EPC PACKAGE FOR LARA SUPER THERMAL POWER PROJECT, STAGE-II (2x800 MW)
Amendment No. 02 to Technical Specifications Section-VI of Bidding Document No.: CS-9587-001R-2

Doc. No.: CS-9587-001R-2-TECH AMDT- 02	LARA SUPER THERMAL POWER PROJECT STAGE-II (2X800 MW)	Amendment No. 02 to Technical Specifications Section-VI
--	---	--

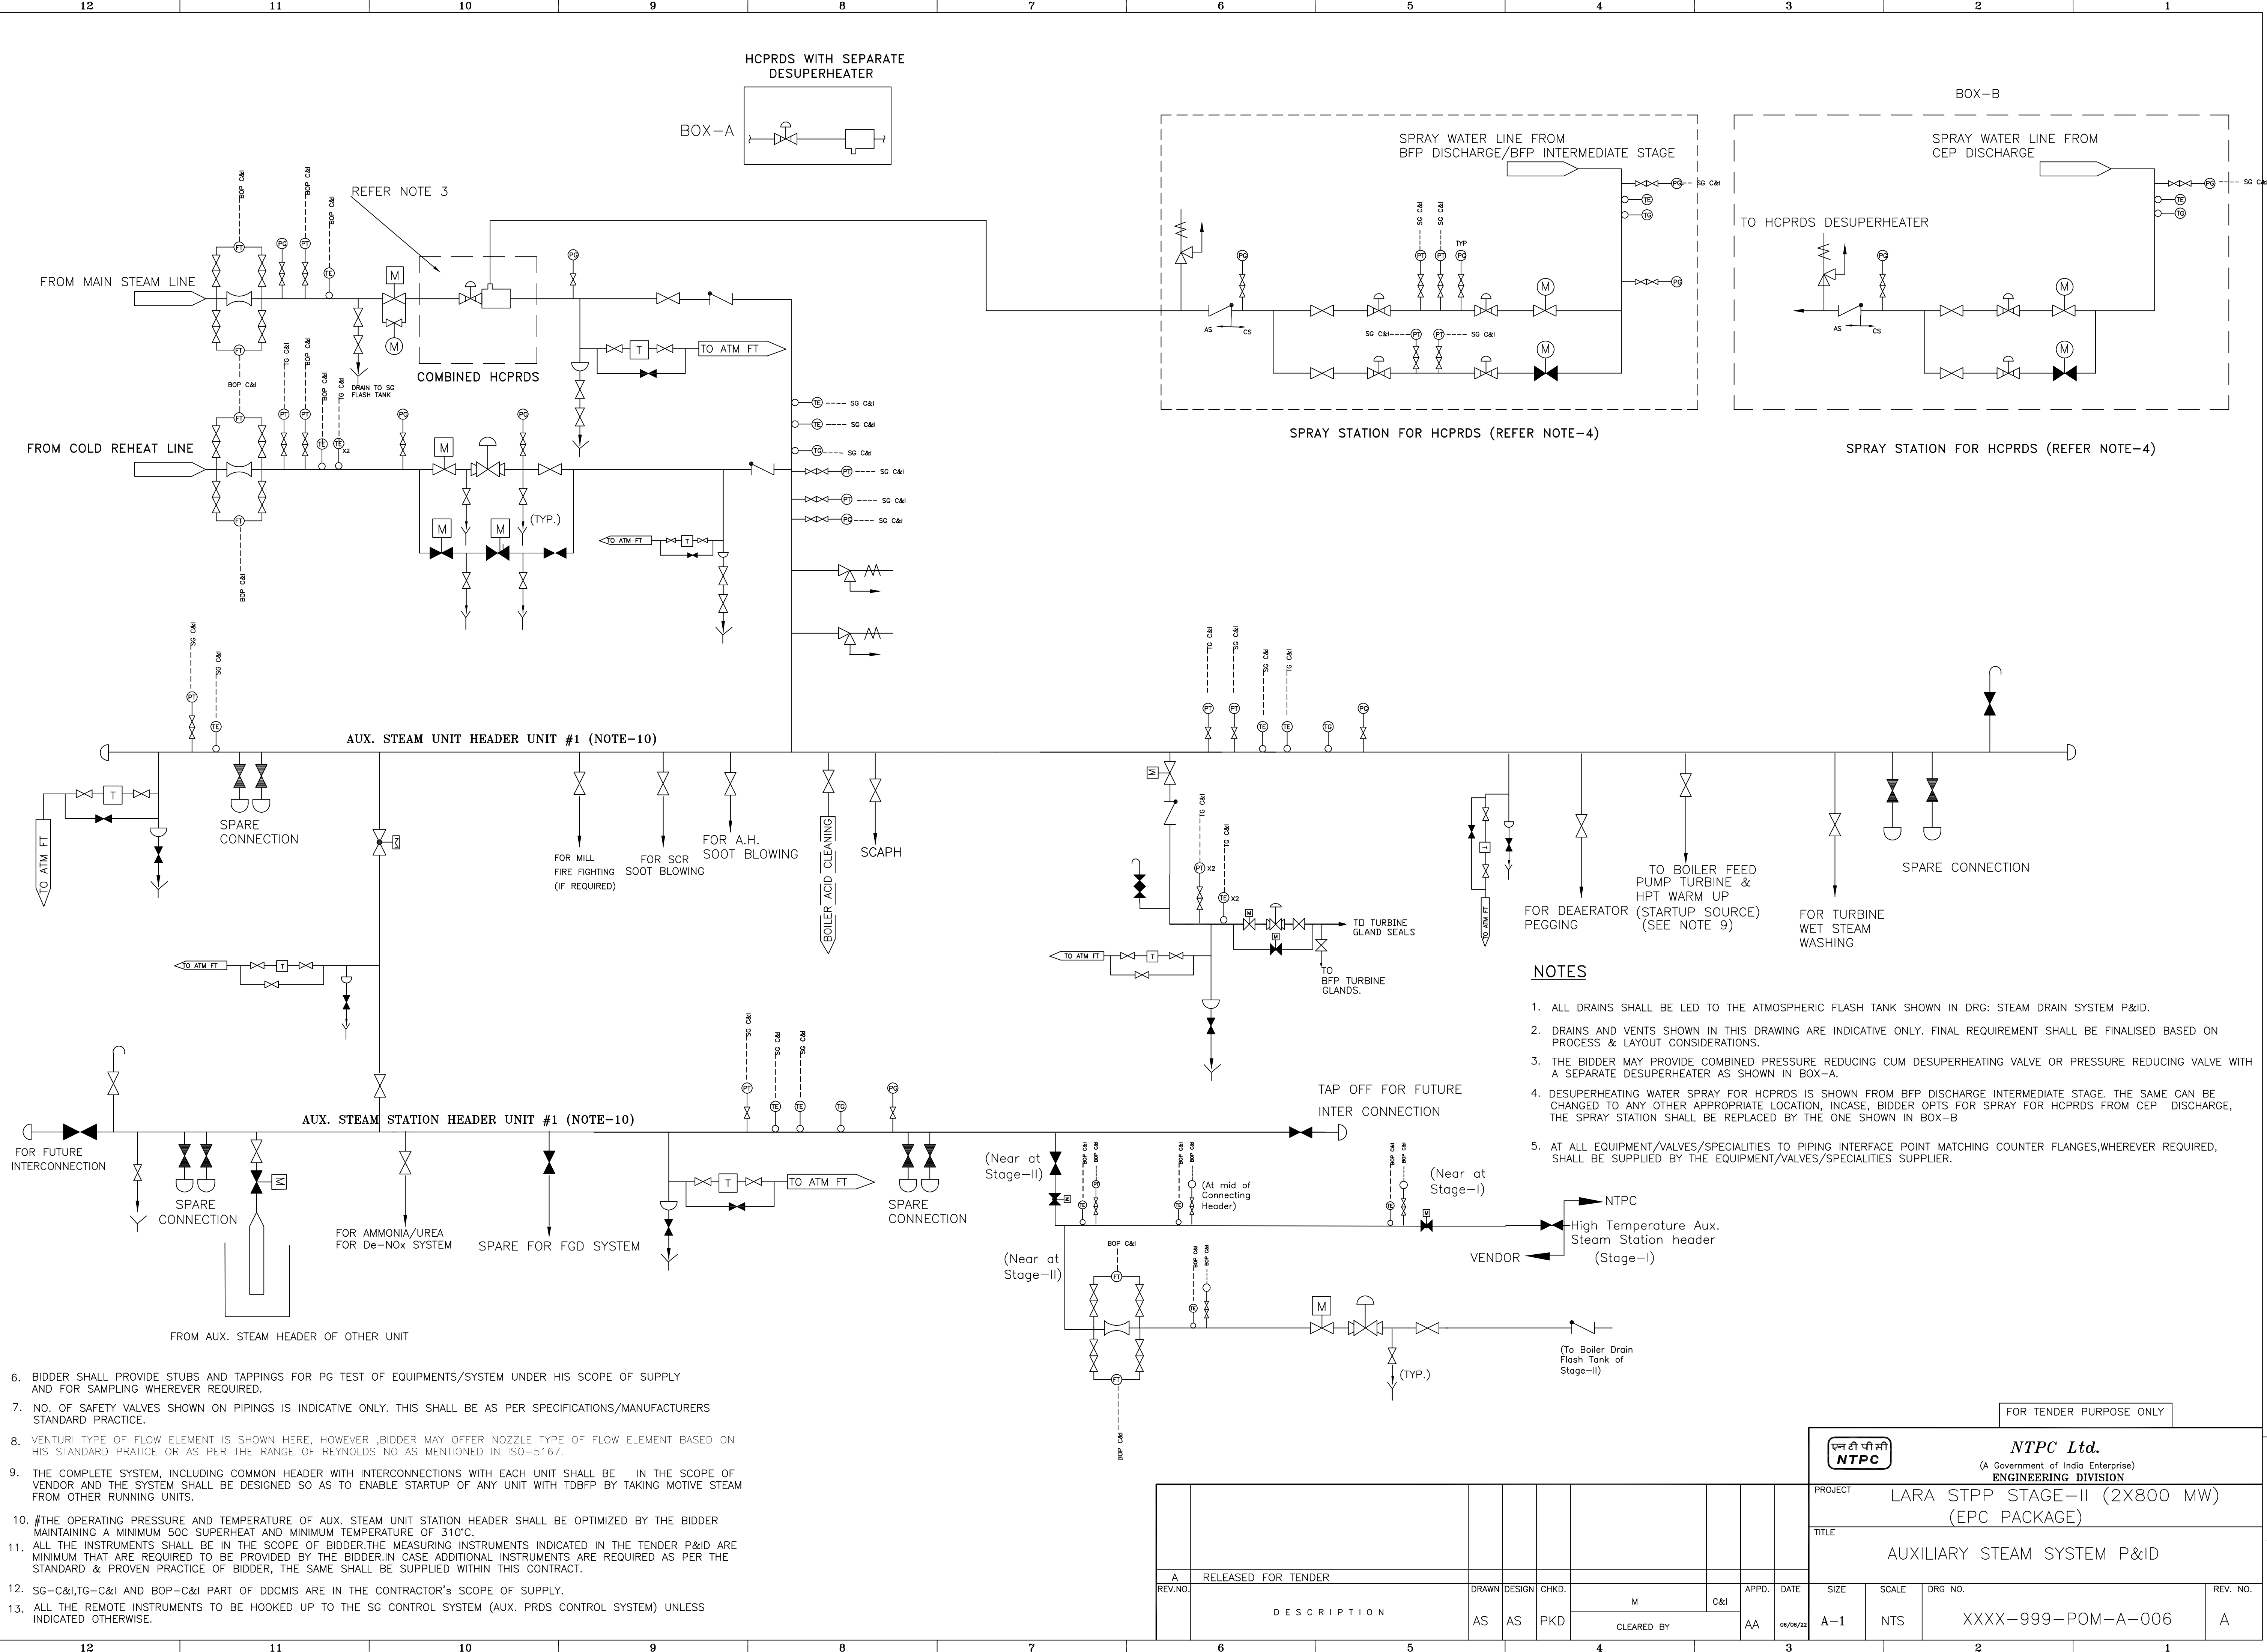
TG1-17	Part-E		XXXX-999-POM-A-006		Auxiliary Steam P&ID	Revised Auxiliary Steam P&ID
TG1-18	VI/B	A-07	5.01.00	11 of 25	Low Pressure Heaters and Drain Cooler	Low Pressure Heaters and Drain Cooler

DRAWING NO.: 9587-001(R)-POM-A-026

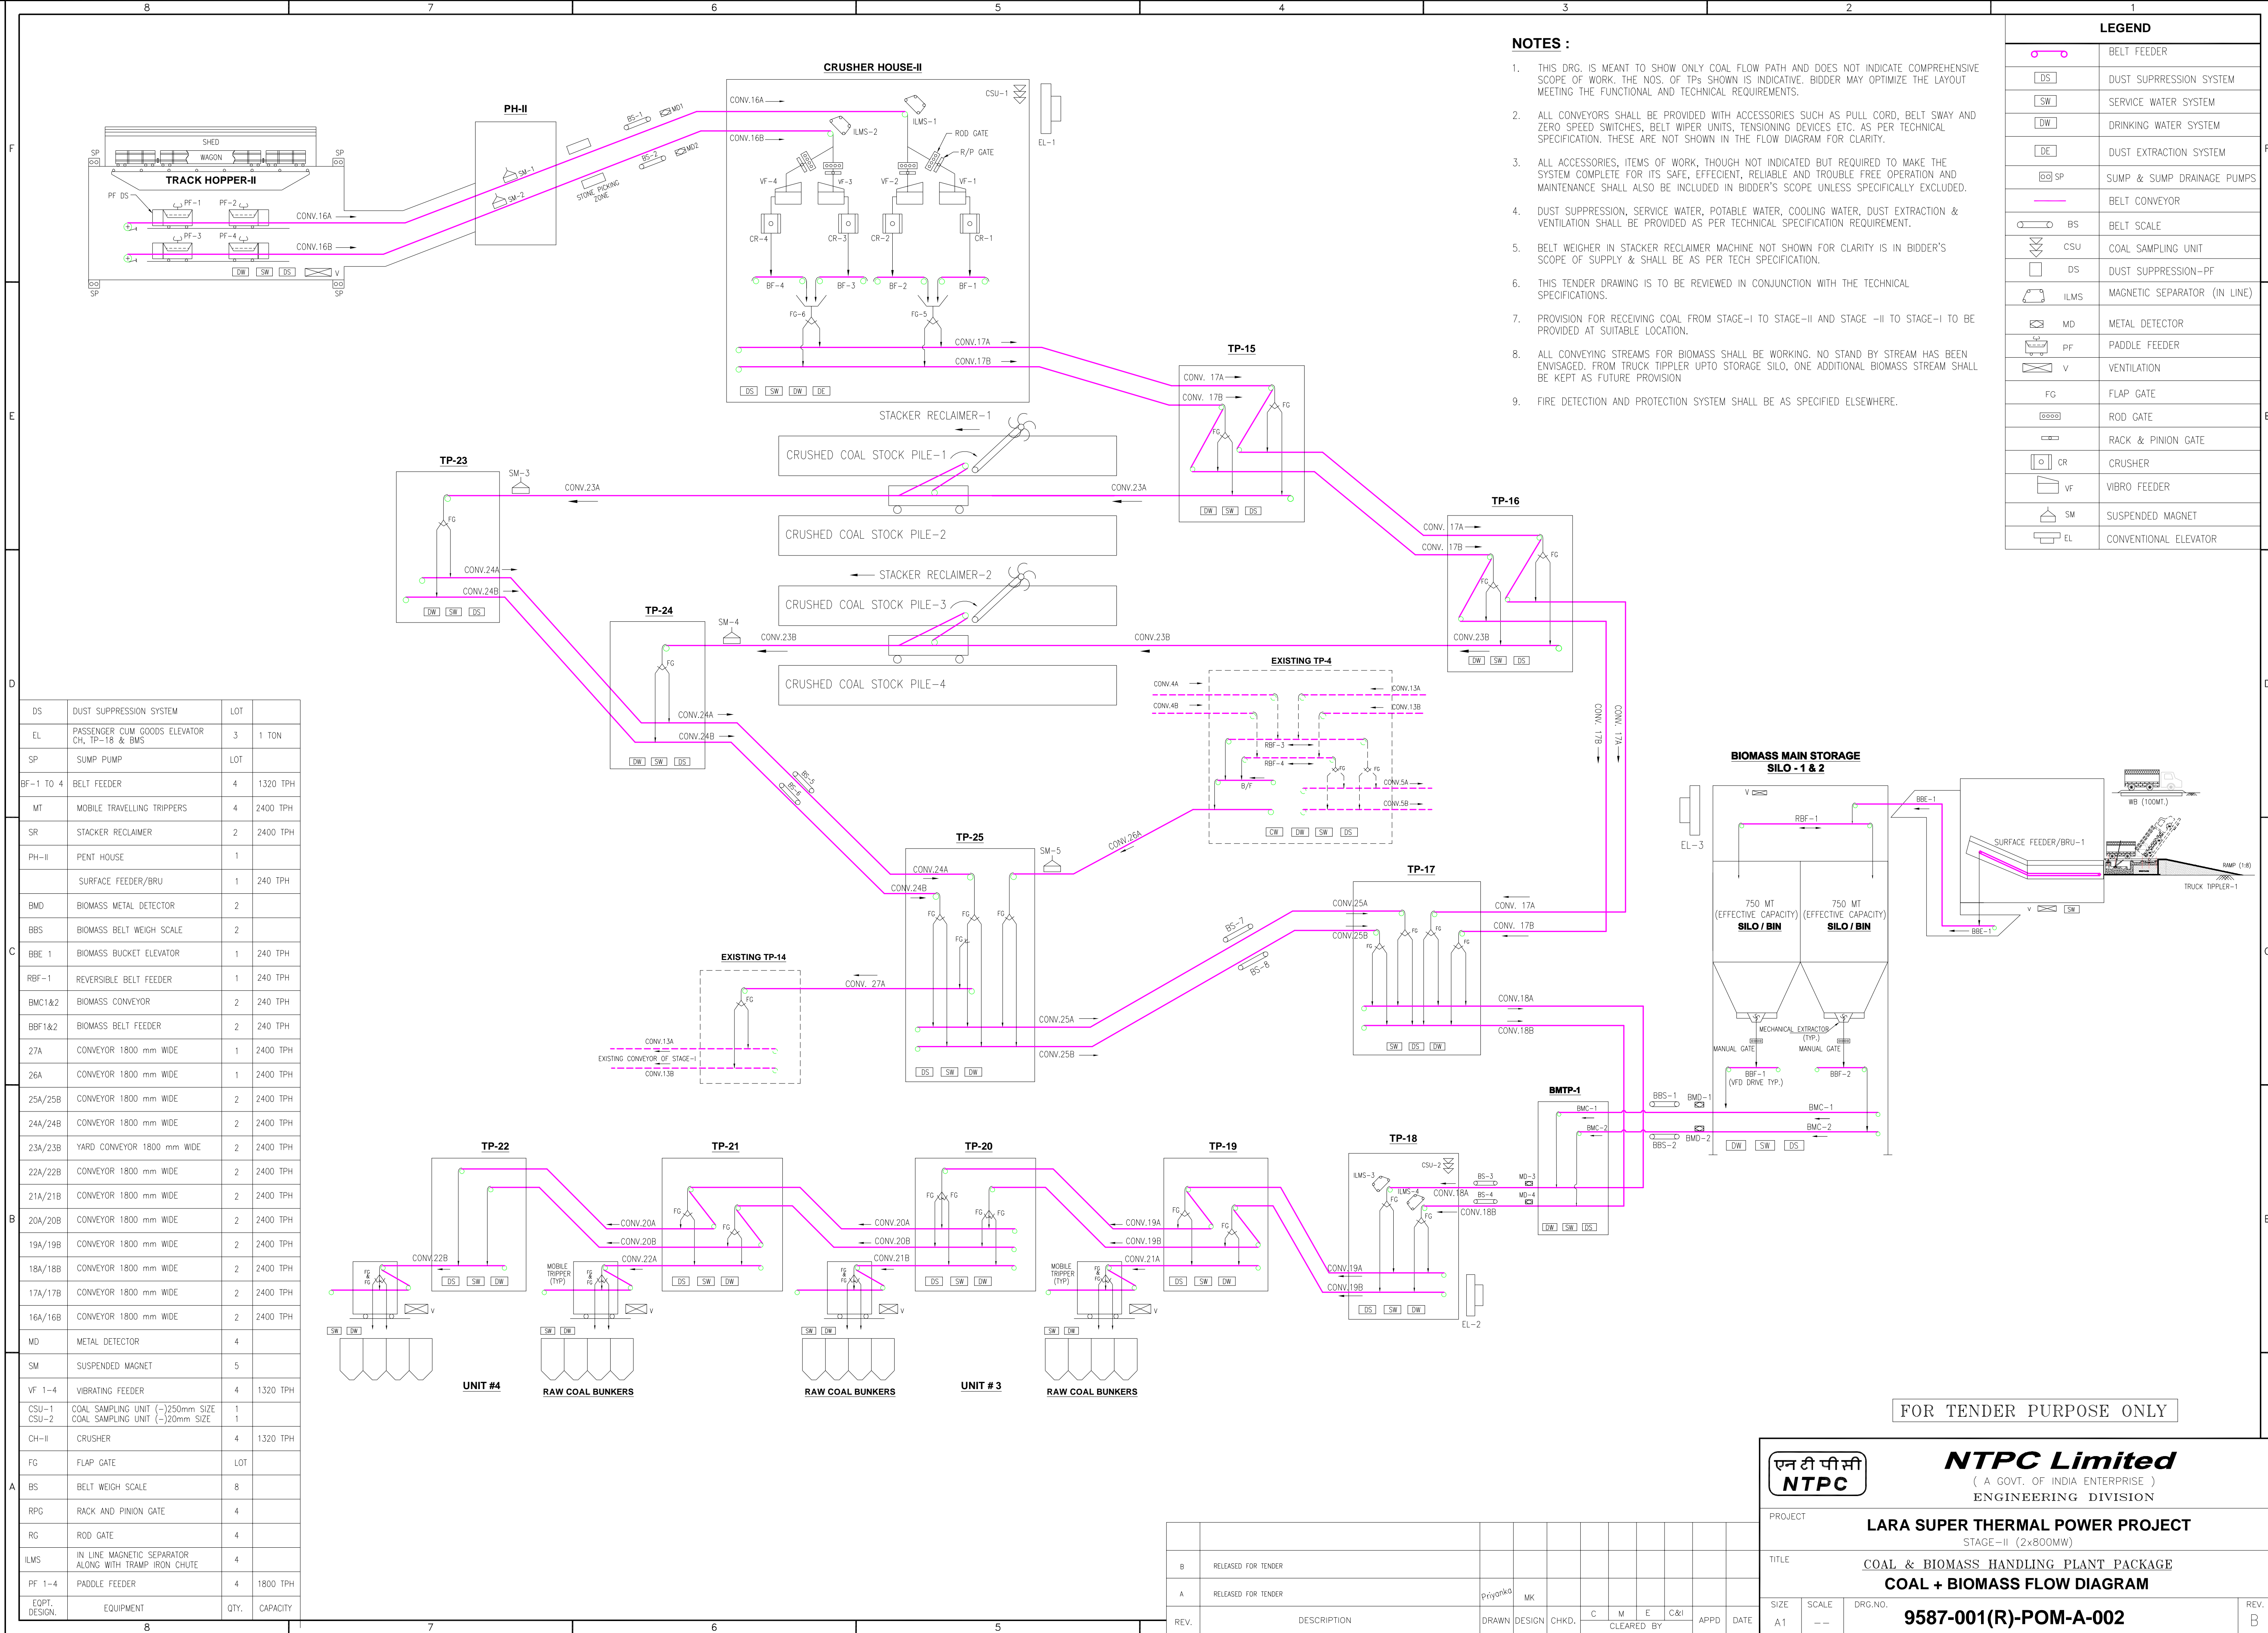
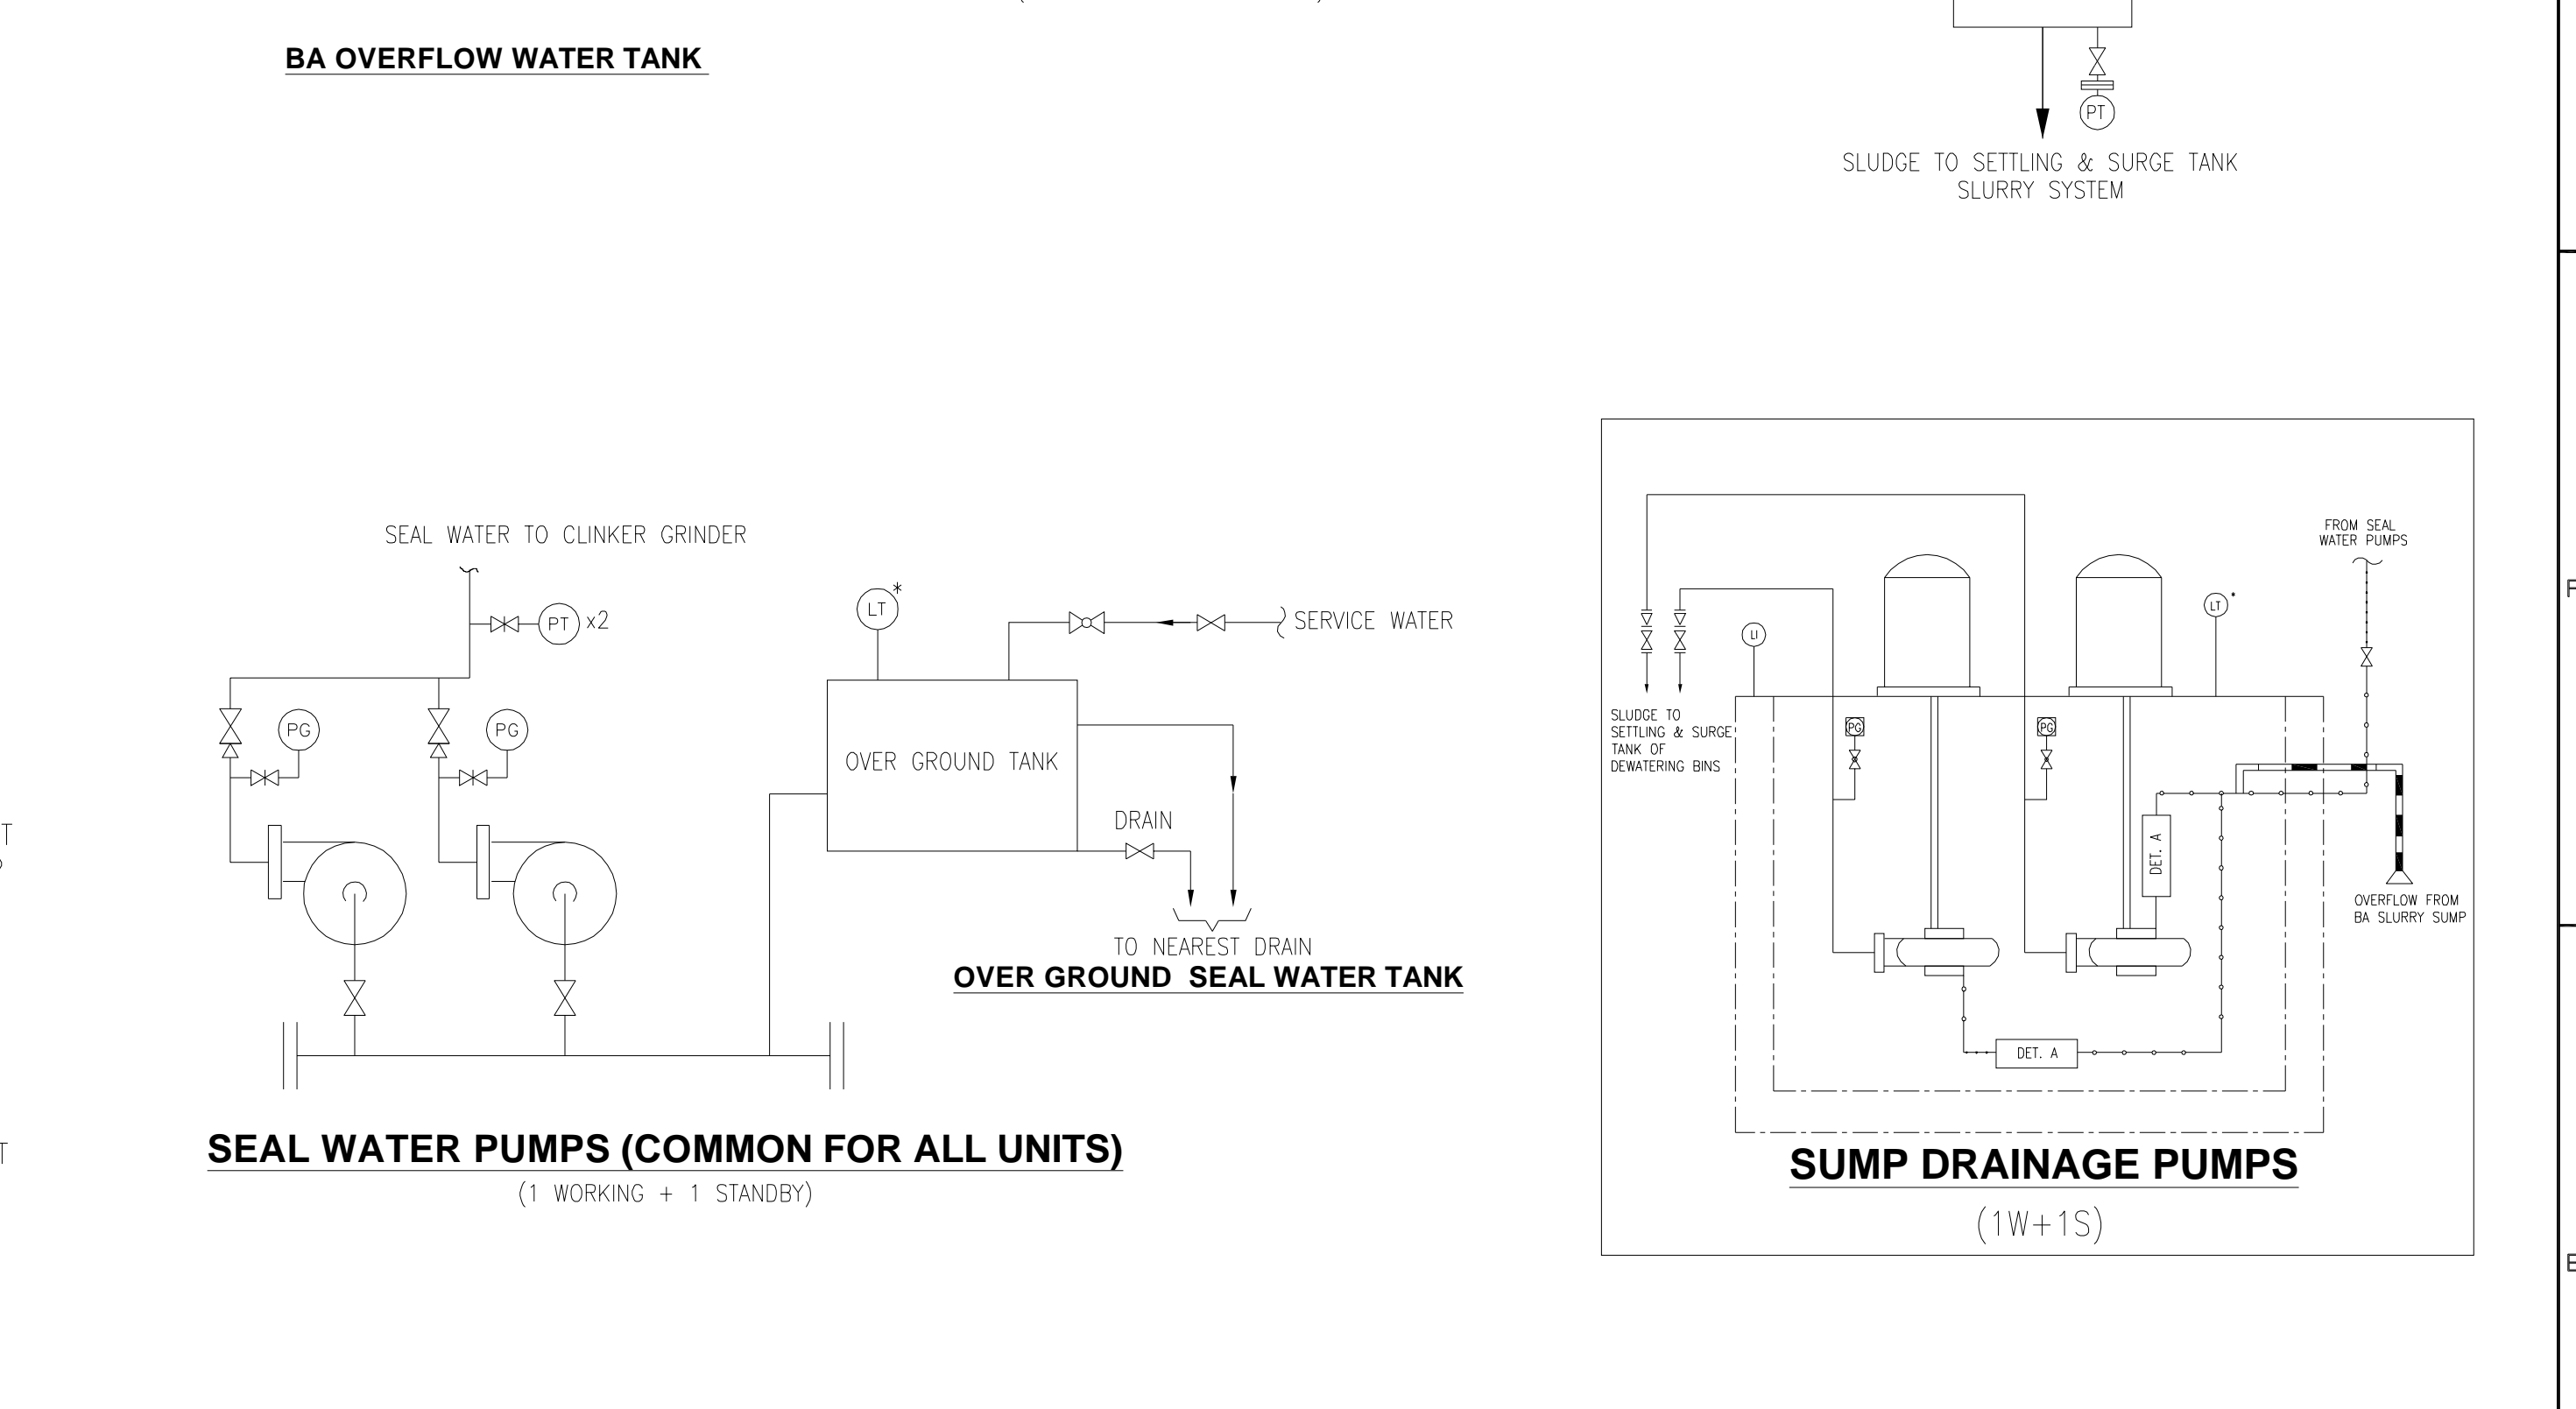
S. No.	SPECIFICATION REFERENCE				Instead of	Read as
	Section / Part	Sub-Section	Clause No.	Page No.		
MH-1	VI/PART-E				9587-001(R)-POM-A-002 R0 9587-001(R)-POM-A-025 R0 9587-001(R)-POM-A-026 R0 9587-001(R)-POM-A-027 R0 9587-001(R)-POM-A-028 R0 9587-001(R)-POM-A-029 SH1 R0 9587-001(R)-POM-A-029 SH2 R0	9587-001(R)-POM-A-002 R1 9587-001(R)-POM-A-025 R1 9587-001(R)-POM-A-026 R1 9587-001(R)-POM-A-027 R1 9587-001(R)-POM-A-028 R1 9587-001(R)-POM-A-029 SH1 R1 9587-001(R)-POM-A-029 SH2 R1
MH-2	VI/PART-A	IIA-15	2.03.00	5 OF 8	Space and interface provision for one (1) additional stream of Truck Tippler, BRU/Surface Feeder and Bucket Elevator shall be kept for future eventuality.	Space and interface provision for one (1) additional stream of Truck Tippler, BRU/Surface Feeder and Bucket Elevator shall be kept for future eventuality considering following as a minimum a. Ramp to be constructed considering for both truck tippler. b. BRU station / building to be sized considering two no's BRU unit & feeding system. c. Bucket elevator supporting arrangement shall be considered from silo for two no's bucket elevators. d. Silo is to be designed for two streams of conveyor feeding. (One is for St-II + One future stream) e. Handling arrangement to be designed considering future equipment also.
